MONTGOMERY COUNTY HISTORIC PRESERVATION COMMISSION STAFF REPORT

Address:	13 Cleveland Ave., Takoma Park	Meeting Date:	2/21/18
Resource:	Contributing Resource Takoma Park Historic District	Report Date:	1/14/18
Applicant:	Brad & Kathy Dorman	Public Notice:	2/7/18
Review:	HAWP	Tax Credit:	n/a
Case Number:	37/03-18K	Staff:	Dan Bruechert
Proposal:	Rear Deck, Fence, and Hardscape Alteration

DRIVEWAY

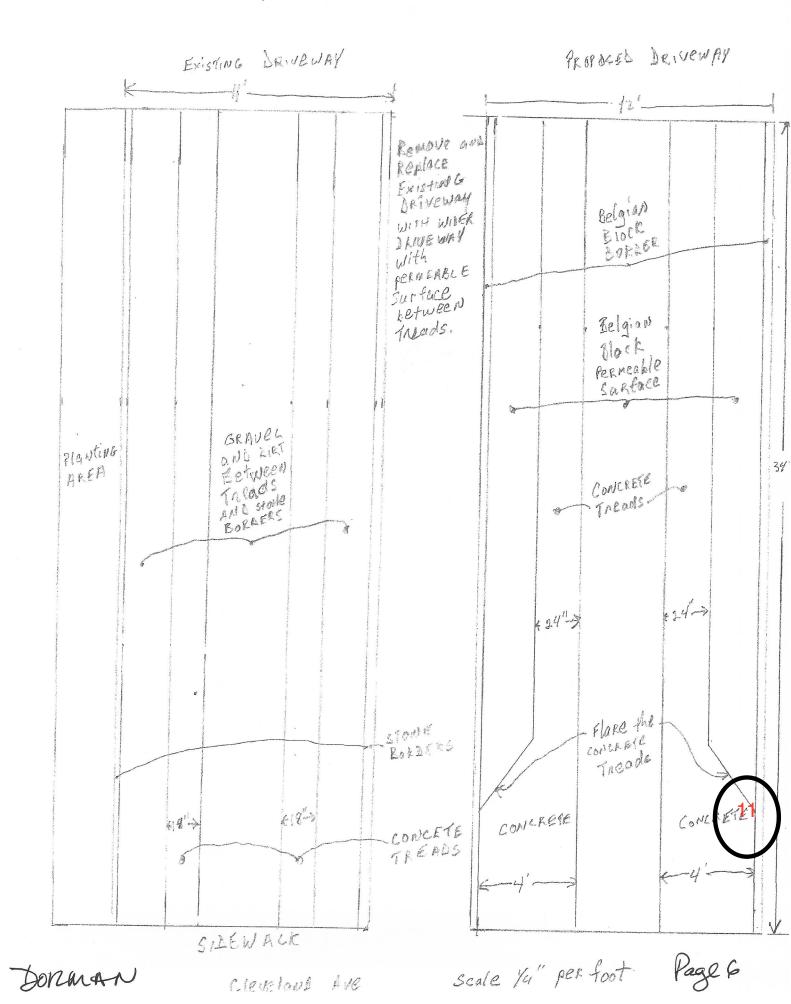
The applicant proposes to remove the concrete ribbons and gravel infill in the driveway. The new driveway will be one foot (1') wider than the existing and will have slightly wider concrete ribbons and will be in-filled with "Belgian Block." Staff is generally supportive of the proposal, however, specifications of the materials proposed were not included with the application materials. Staff has reached out to the applicant for clarification and will update the HPC with this information. Absent these specifications, Staff does not believe that consideration of this HAWP should be delayed and instead recommends that any approval of the driveway replacement be conditional on the review and approval of these materials with final approval authority delegated to Staff. Staff feels that the replacement concrete ribbons should use a concrete with an exposed aggregate to create a textured appearance and darker color that is more consistent with historic concrete mixes. A bright white, smooth concrete is not appropriate. "Belgian Block" typically refers to rustically dressed granite blocks. Staff finds that this material

is an appropriate infill material as its natural color and rough texture will blend in with the surrounding landscape. Staff also finds that the one-foot (1') increase in the width of the driveway will not substantially alter the character of the driveway and supports approval with a condition requiring Staff review of the proposed concrete.

1. Specifications for the concrete proposed for the concrete ribbons in the front driveway must be submitted for review and approval with final approval authority delegated to Staff.

FRONT WALK

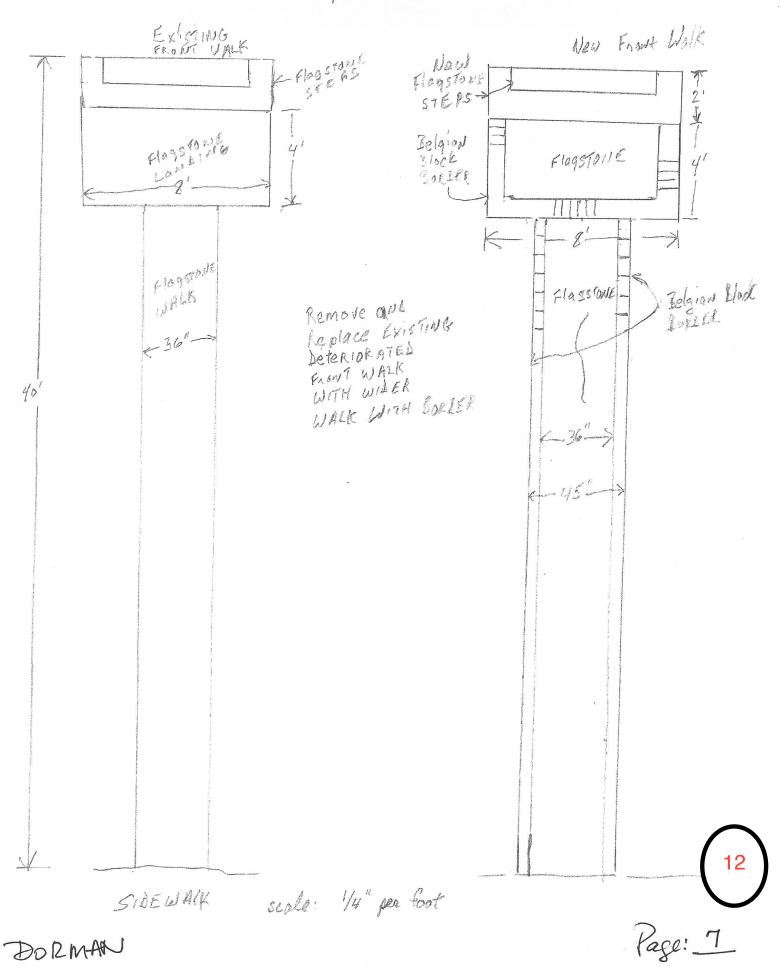
The applicant is proposing to widen the front walk by nine inches (9") using a "Belgian Block" border and to replace the front flagstone steps with thicker flagstones. Staff finds that neither of these proposals will have a significant impact on the historic resource and the block border will visually tie in with the proposed work on the driveway. This proposal respects the environmental setting and landscaping of the house (per the *Guidelines*) and Staff supports its approval.

FENCES :

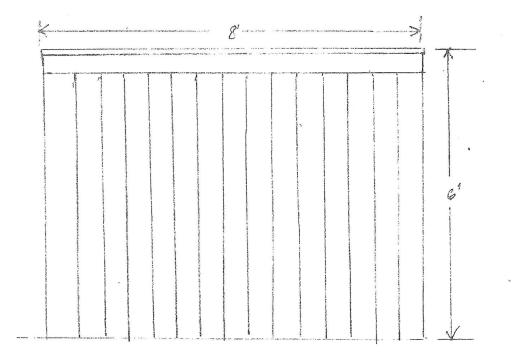
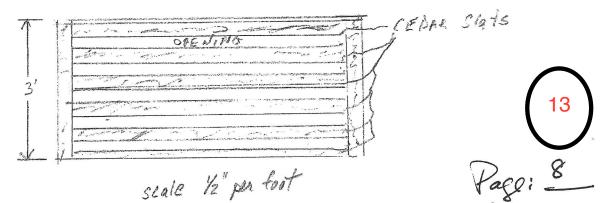
The applicant proposes to construct a six-foot (6') tall privacy fence in the rear of the property; the applicant additionally proposes to construct a three-foot (3') tall fence along the western property boundary in front of the rear wall plane. The rear fence is consistent with the existing fence and its replacement does not require HPC review. However, the three-foot (3') tall fence is a change in the visual/material appearance of the house and does require HPC's review. The proposed fence will be constructed out of cedar and will use horizontal cedar slats alternating with voids. This fence design and material match the fence enclosing the neighboring house at 7417 Baltimore Ave. Staff finds that the materials and design are consistent with the surrounding historic district and supports its approval.
